**81130A-03B**

# S E R V I C E N O T E

## 81100 Family Pulse Pattern Generators

**Intermittent display failures  
(shifting lines, inverted, fully lit or completely dark display)**

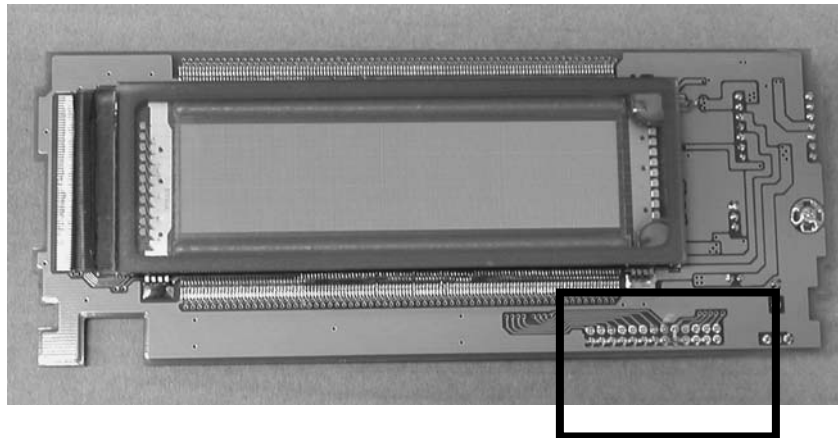
Intermittently the front panel display may show shifting lines that are falling back to their normal state. Additionally an inverted display, a display with all pixels lighted or a blank display may occur intermittently.

After cycling the power of the pulse generator the display works normally again. Reproducing the symptom might not be possible.

- Remove the front frame and unplug the connector cable from the 81100 mainframe.
- Carefully remove the display module from the front frame and check for a capacitor that might have been added during an earlier intermittent modification (see picture below). If there is such a capacitor, unsolder it from the module. Re-install the display into the front frame.

- On the 81100 mainframe replace the existing filter plate with the new filter plate, p/n 0960-0996. The new filter plate can be identified by a single connector pin that shows a red color code.
